**FILE REF.:** CASE # V17-5520 Oreo, LLC Variance

Oreo, LLC., Applicant, Design Enginuity (Oralynn Guerrerortiz) Agent, request a variance to the requirements set forth in the Sustainable Land Development Code (SLDC) of Chapter 7, Table 7-13: Rural Road Classification and Design Standards (SDA-2 and SDA-3) to allow a (250) ft. section of South Summit Drive to exceed 9% grade and a variance of Chapter 7, Section 7.17.10.7.8 Screening Requirements to allow existing (14) ft. retaining walls to exceed the (5) ft. height limitation.

RE: High Summit III – Phase 2 Variance Request

HIGH SUMMIT III - PHASE 2

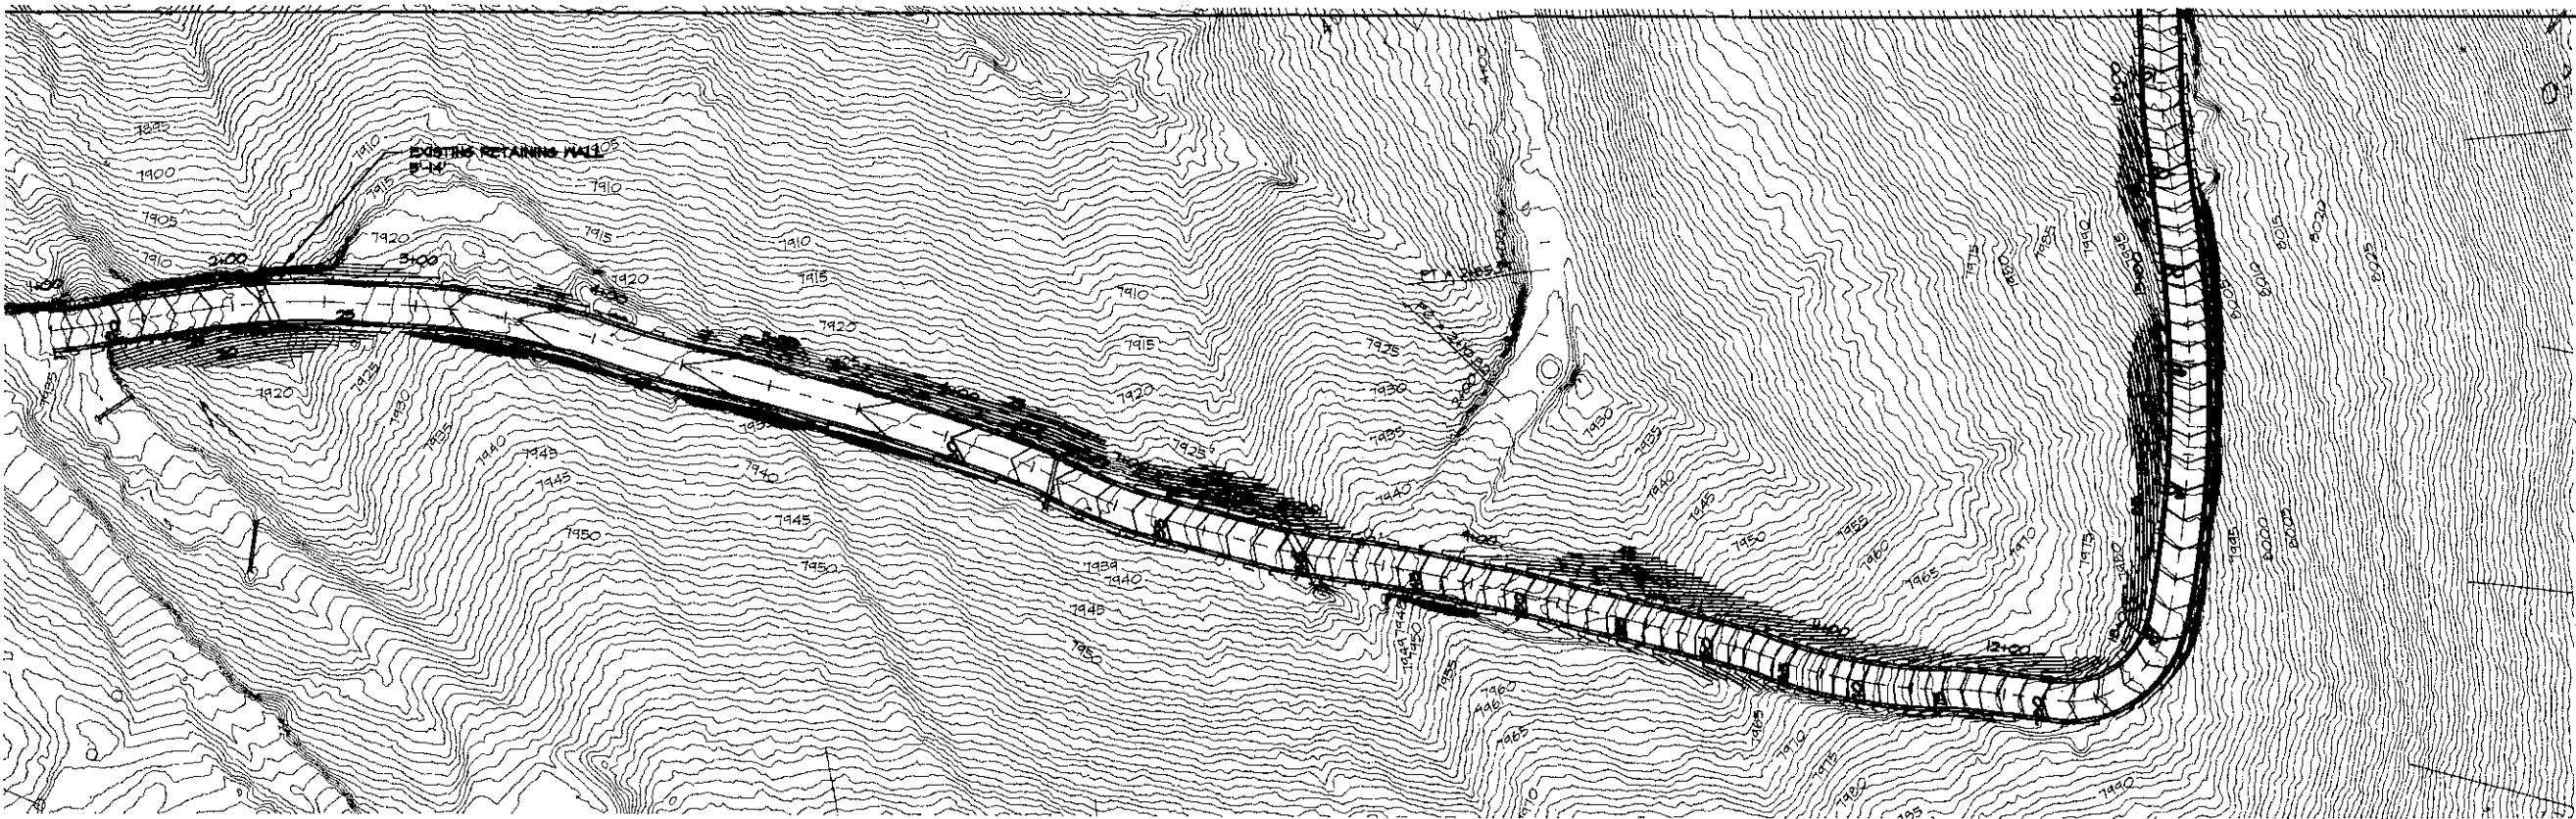
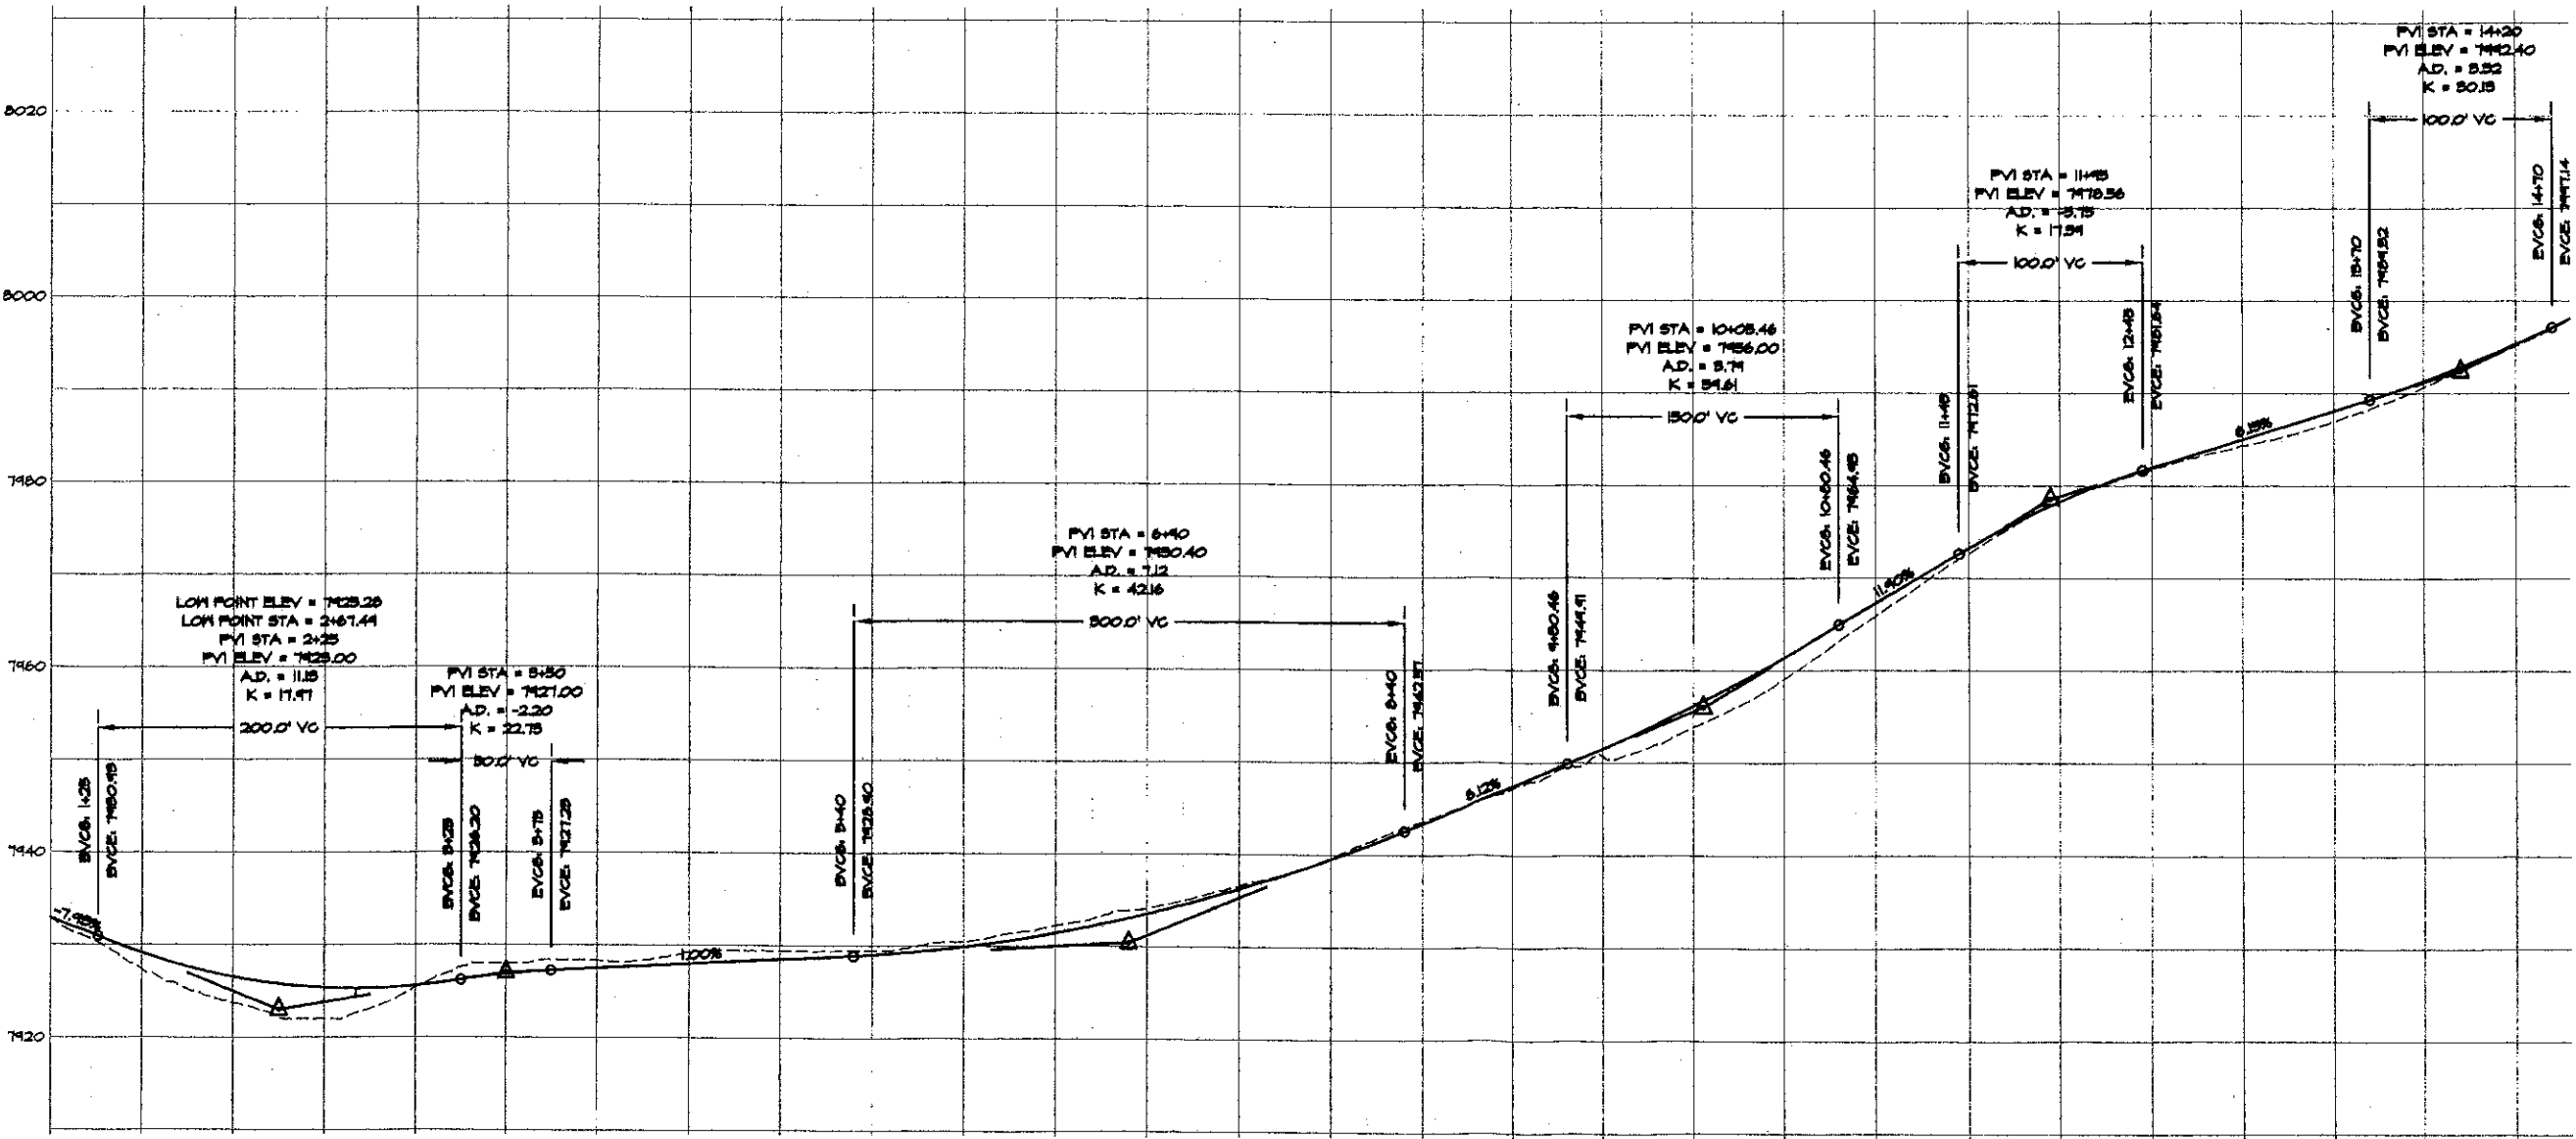
**Staff Response:** On the project site there are two 14 ft. retaining walls as indicated on the Plan and Profile (Exhibit 7). Staff has confirmed that leaving the existing retaining walls would have less impact to the terrain, less impact to existing vegetation and would minimize grading and fill to the terrain. The applicants

**Staff Response:** Existing large trees, shrubs and other existing vegetation, currently screen the retaining walls. If the Applicant were to modify these 14 ft. retaining walls to the current SLDC requirements of 5 ft., extensive grading and disturbance of slopes would have to occur, and a significant amount of vegetation including large trees and shrubs would have to be removed.

**Staff Response:** The existing retaining walls are difficult to see from any other roadway with the exception of possibly anyone living within the phase of the project. Reducing the retaining wall height would require major disturbance to the surrounding terrain.

1. An engineer will certify the structural integrity of the retaining walls and ensure that the retaining walls are properly permitted.
